# HISTORIC PRESERVATION REVIEW BOARD STAFF REPORT AND RECOMMENDATION

Address: 300 G Street SE

Case Number: 22-230

Applicants William Cox and Audrey Draper, with plans prepared by Eric Teran, seek concept review for a rear two-story addition at a property located in the Capitol Hill Historic District.

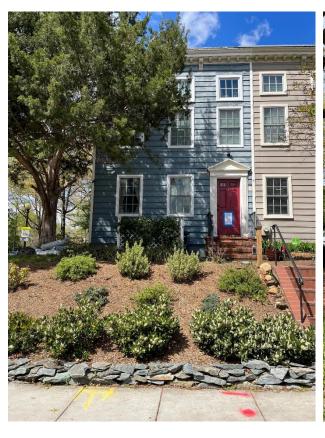
The addition would be highly visible. The project is compatible in design and efforts have been made to differentiate it from the main block. This could be further accomplished by insetting the

addition from the main block. The amount of glazing for the three sliding glass doors might be less overwhelming on the side elevation if those were revised to show paired French doors instead. More information on the siding materials is needed.
